CERTIFICATE OF APPROPRIATENESS**Application Date:** March 2, 2016**Applicant:** Matt Grauvogl, RSFM Inc. for Kimberlee Sturrock, owner**Property:** 1122 Peddie Street, Lots 7 & 8, Block 111, North Norhill Subdivision. The property includes a historic 1,152 square foot, one-story wood frame single-family residence and a detached garage situated on a 10,000 square foot (100' x 100') interior lot.**Significance:** Contributing bungalow residence, constructed circa 1926, located in the Norhill Historic District.**Proposal:** Alteration – Windows/Door

Recommendation: **Partial Approval: Approval to remove the side door and fill in the opening; Approval to replace window O with a wood 1-over-1 window of the same size in the same location; Denial of all other work.**

WEST SIDE ELEVATION

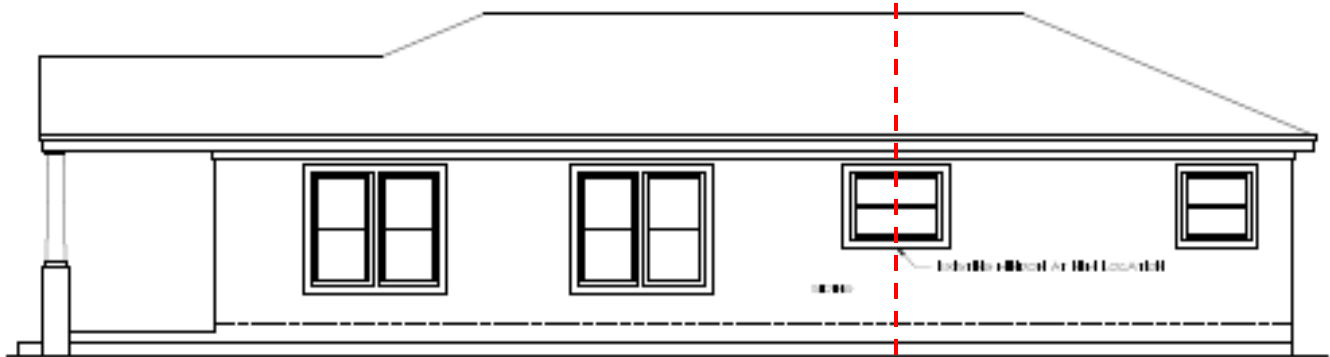
- West (side) elevation: Remove a non-original door and side over the opening; Remove a 1-over-1 window and shift it 1'-6" feet towards the rear.
- East (side) elevation: Remove a pair of wood 1-over-1 windows and install a smaller 1-over-1 window.

<i>Altering window locations removes interior shiplap which compromises the integrity of the building.</i> |

Side Elevation: This elevation contains six wood 1-over-1 windows and a pedestrian door. The alteration replaces
(West) five with new windows in the same location and removes the door and encloses the opening. The sixth 32" by 36" 1-over-1 window is removed and shifted 1'-6" towards the rear.

EAST SIDE ELEVATION

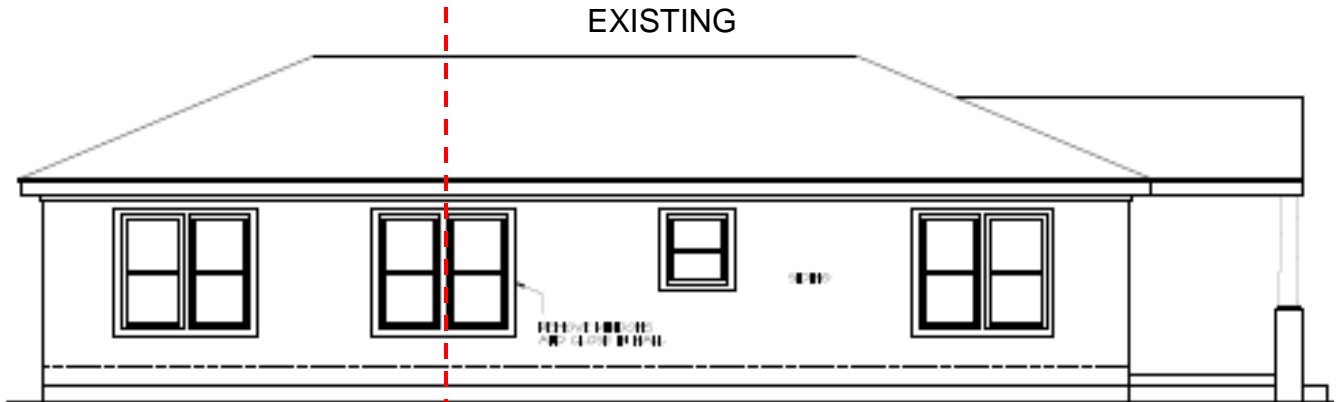
Side Elevation: This elevation contains seven wood 1-over-1 windows. The alteration removes two windows and
(East) installs a smaller 32" by 36" 1-over-1 window.
